**Re: System Strength Requirements Methodology and System Strength Impact Assessment  
Guidelines amendments consultation**

**For** AEMO **Date** 19 August 2022  
**From** DlgSILENT Pacific **Subject** SSRM and SSIAG amendments consultation

Figure 1: SCR ramp down results with various load factors ( $I_f$ ). The load factor is size of the load at the POC.

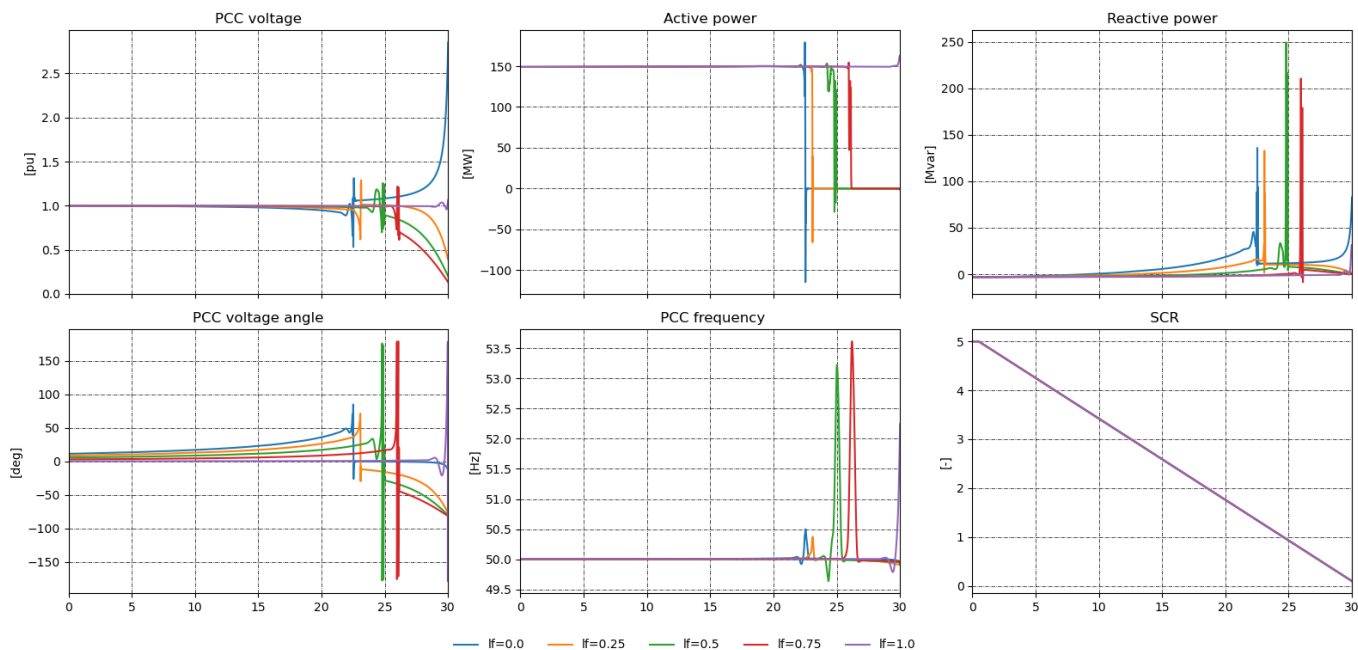
Another factor that also has a significant effect on the calculated minimum SCR is the presence of load at the plant’s POC within the SMIB model. This represents the effect of loads within the vicinity of the plant consuming some of the active power that the plant produces. In some instances, particularly where the plant is located within a load centre, the size of this load may be greater than the plant rating. Not including this load entails that all the power generated by the plant is transferred to the source through the source impedance. This introduces a limit on the feasibility of the steady state operating point as the steady state voltage angle difference across the SMIB network (ignoring the effect of transformer phase shifts) must be less than 90 degrees for a viable solution for **any** technology. This steady state limit equally applies for synchronous machines, GFM IBRs or GFL IBRs and hence cannot be used as a system strength indicator.

To illustrate the effect of this load on the calculated minimum SCR result, the following EMT simulation has been carried out (with plots provided in Appendix A Figure 1):

- A EMT SMIB model has been configured (using the OEM detailed EMT model for a GFL IBR) with a voltage source to achieve a POC voltage of 1.0 pu with an SCR of 5 and an X/R ratio of 10.
- The plant is dispatched to 1.0 pu active power output and 0.0 pu reactive power output.
- A resistive active power load is placed at the POC.
- The model is initialised with an SCR of 5 and the SCR is slowly ramped down over time (by varying the source impedance) until plant instability is observed.

The table below shows the SCR values attained prior to the onset of instability for varying load sizes (as a proportion of the initial plant active power dispatch). It is observed different load factors lead to different minimum SCR results.

Figure 2: SCR ramp down results with various ways to achieve an initial 1.0 pu voltage at the POC. The “V source” method varies the source voltage magnitude whereas the “Q shunt” method varies a capacitive shunt at the POC to achieve this.

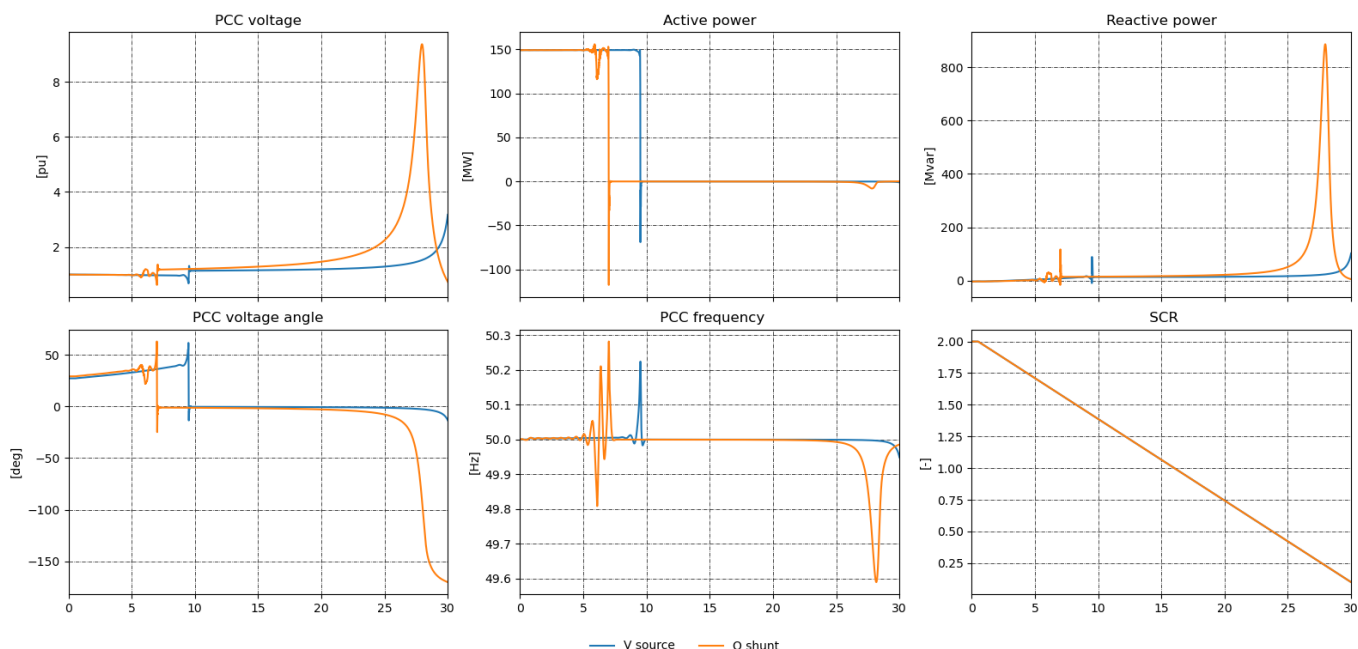
Lastly, the representation of static shunts at the POC of the plant can also influence the calculated minimum SCR result. To provide an indication of the effect of on the calculated minimum SCR result, a similar simulation to the load representation case is carried out (with plots provided in Appendix A Figure 2):

- A EMT SMIB model has been configured (using the OEM detailed EMT model for a GFL IBR) with an SCR of 2 and an X/R ratio of 10.
- The plant is dispatched to 1.0 pu active power output and 0.0 pu reactive power output and no load is placed at the POC.
- The initial POC voltage of 1.0 pu is achieved using two different methods: in one case voltage source magnitude is modified (V source) and a shunt is introduced at the POC with the voltage source magnitude fixed at 1.0 pu (Q shunt).
- The model is initialised with an SCR of 2 and the SCR is slowly ramped down over time (by varying the source impedance) until plant instability is observed.

The table below shows the SCR values attained prior to the onset of instability for different static shunt model representation.

### B.1 Case study 1

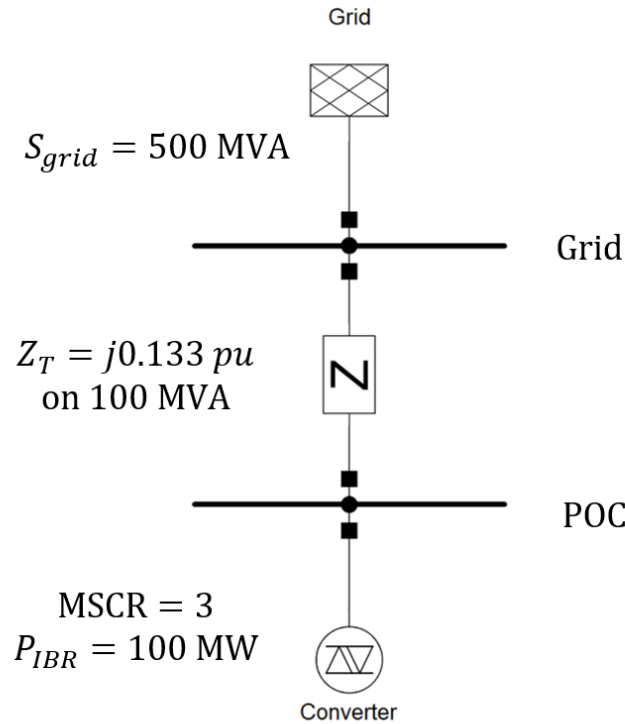
In this case study the result of the AFL and SCR methods align.

## B.2 Case study 2

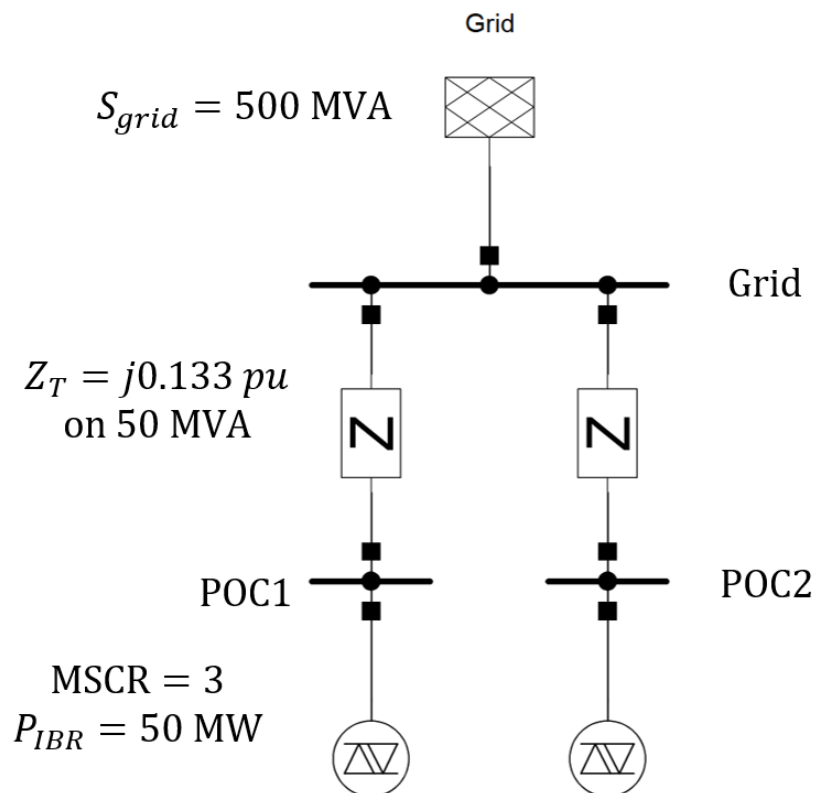
In this case study the fault levels and IBR connected to the POC bus are identical to case study 1. Whilst the result of the AFL and SCR methods align at the POC, they do not align at the grid bus indicating an inaccuracy in the AFL method for remote buses.

The AFL method incorrectly calculates sufficient system strength at the grid bus. This is indicative of its inaccuracy for calculating system strength requirements at remote buses.
